**PLANNED UNIT DEVELOPMENT
& SUBDIVISION STAFF REPORT****Date: June 2, 2016****DEVELOPMENT NAME**

Revised Snowden Place Subdivision

Planned Unit Development Approval to amend a previously approved Planned Unit Development to allow reduced front and side yard setbacks, and increased site coverage for a proposed lot in a private street subdivision, and creation of a single lot.

SITE PLAN

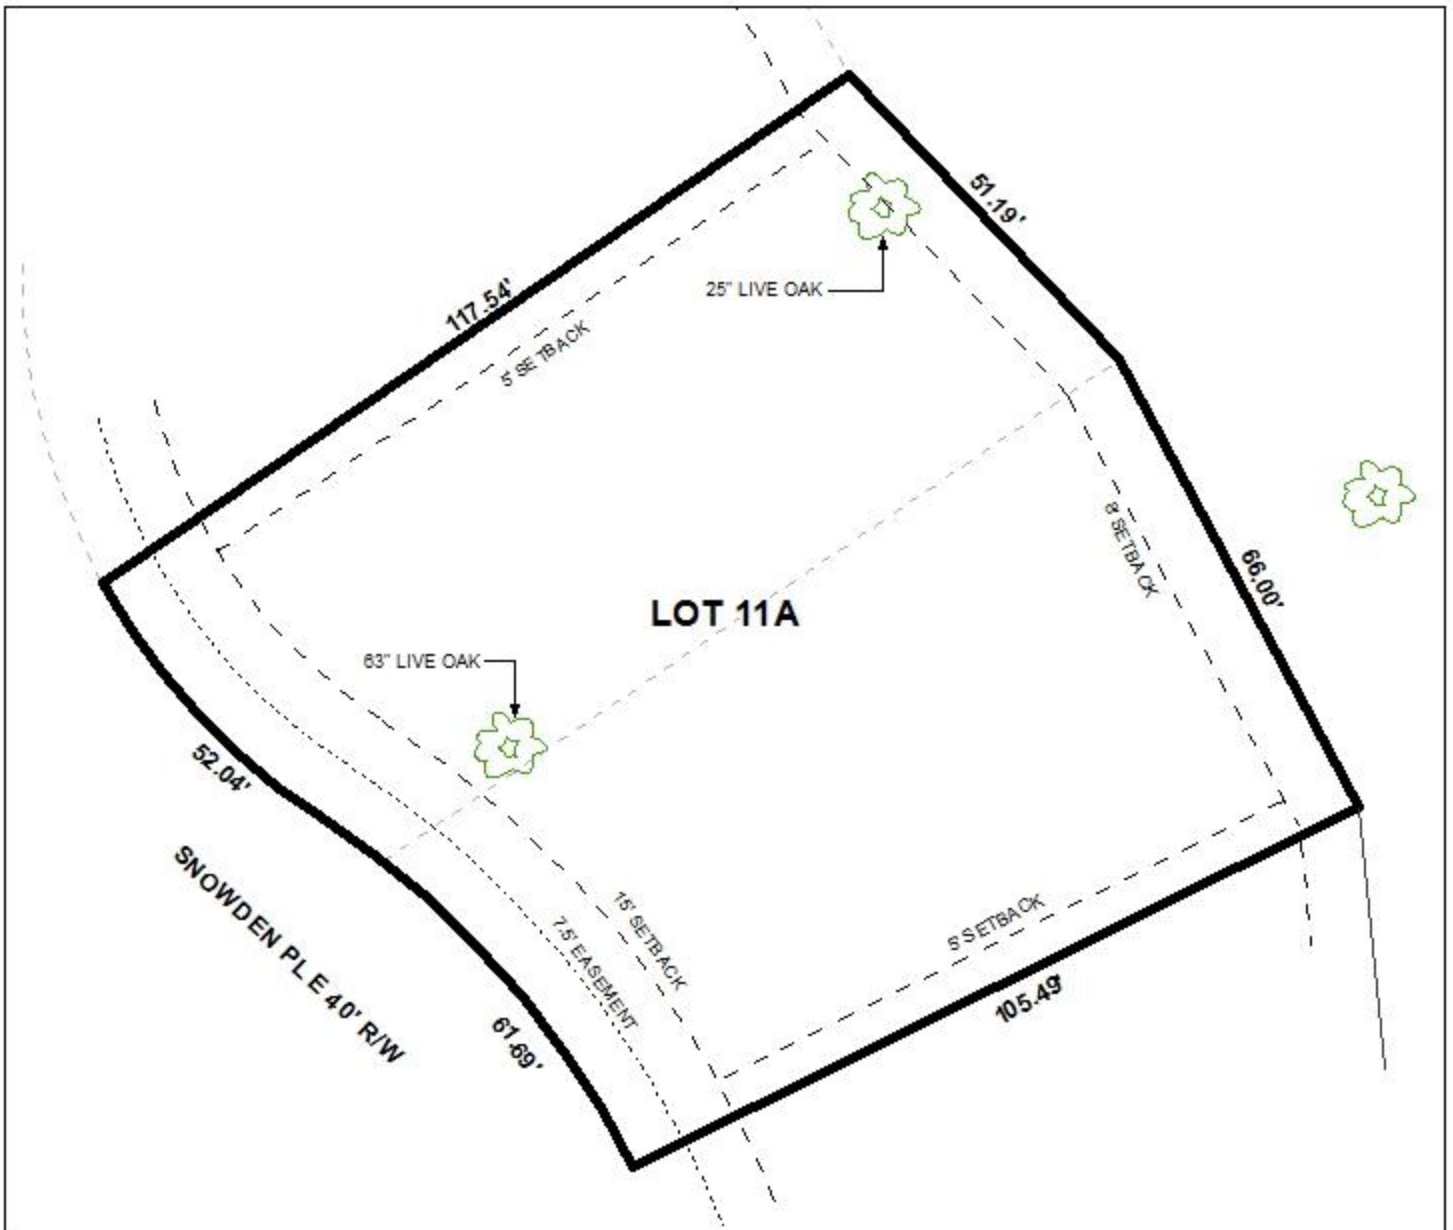
The plat does not indicate the 25" and 63" Live Oak trees as shown on the PUD site plan but which are covered under the Urban Forestry comments. Therefore, a note should be placed on the Final Plat stating that the 25" and 63" Live oak trees are granted Preservation Status and a separate note for each should be placed on the Final Plat and PUD site plan addressing the Critical Root Zone building footprint restrictions.

The only proposed changes to the originally-approved PUD are the removal of the common interior property line and accompanying side yard setbacks and the revision of the site coverage table. The site plan contains a table indicating the lot area in square feet (12,375), the maximum buildable area in square feet (8,979) and the individual site coverage ratio (72.56%). The buildable area and site coverage ratio calculate to be the entire area of the lot minus the area within the building setback lines. However, Urban Forestry has determined that, due to the Preservation Status to be granted to the 25" and 63" Live Oak trees, a Critical Root Zone (CRZ) of one-half the diameter of each tree should be placed around the trees and no structure should be constructed within this area so as to protect the root systems and drip lines of the trees. Therefore, the table providing the maximum buildable area and site coverage ratio should be revised and reduced by the areas of the CRZ for each tree. Notes to this effect should be placed upon a revised site plan.

The site plan contains two diagrams indicating typical lot building limits for the over-all Revised Snowden Place Subdivision. However, as specific building limits would apply to the proposed lot due to the Urban Forestry limitations, these two diagrams should be replaced by one indicating the building limits after the Critical Root Zone limits are included.

A note should be placed on the site plan stating that the lot is limited to one curb cut, with the size, location and design to be approved by Traffic Engineering and conform to AASHTO standards. The reference on the existing note to restricting direct access to Cottage Hill Road should be removed. The note on the site plan referencing the private street gate remaining operational should be retained.

A note should be placed on the site plan stating that the maintenance of the Common Areas and the private street are the responsibility of the property owners.

A note should be placed on the site plan indicating that individual private garbage service will be provided

- 1) retention of the lot size label in both square feet and acres, or the furnishing of a table on the site plan providing the same information;
- 2) retention of the front, side and rear yard setbacks on the site plan;

- 3) placement of a note on the site plan stating that the 25" and 63" Live Oak trees are granted Preservation Status;
- 4) placement of a note on the site plan stating that no structure may be placed within the Critical Root Zone of 12.5' around the 25" Live Oak Tree;

- 5) placement of a note on the site plan stating that no structure may be placed within the Critical Root Zone of 31.5" around the 63" Live Oak Tree;
- 6) revision of the table providing the maximum building area and site coverage ratio for the lot to be reduced by the areas of the CRZ for the 25" and 63" Live Oak trees;

- 7) removal of the two diagrams indicating typical lot building limits for the over-all Subdivision and replacement with one diagram indicating the building limits after the Critical Root Zone limits are included for the subject lot;

- 8) placement of a note on the site plan stating that the lot is limited to one curb cut, with the size, location and design to be approved by Traffic Engineering and conform to AASHTO standards;

- 9) removal of the reference to restricting direct access to Cottage Hill Road;
- 10) retention of the note stating that the gate must remain operational and in use as a condition of the continuation of private street status;

- 11) placement of a note on the site plan stating that maintenance of the Common Areas within the over-all Snowden Place Subdivision is the responsibility of the property owners;

- 12) placement of a note on the site plan stating that individual private garbage service will be provided;
- 13) compliance with Engineering Comments: *[ADD THE FOLLOWING NOTES TO THE PUD SITE PLAN: 1. Any work performed in the existing ROW (right-of-way) such as driveways, sidewalks, utility connections, grading, drainage, irrigation, or landscaping will require a ROW permit from the City of Mobile Engineering Department (208-6070) and must comply with the City of Mobile Right-of-Way Construction and Administration Ordinance (Mobile City Code, Chapter 57, Article VIII). 2. Each Lot Owner shall be*
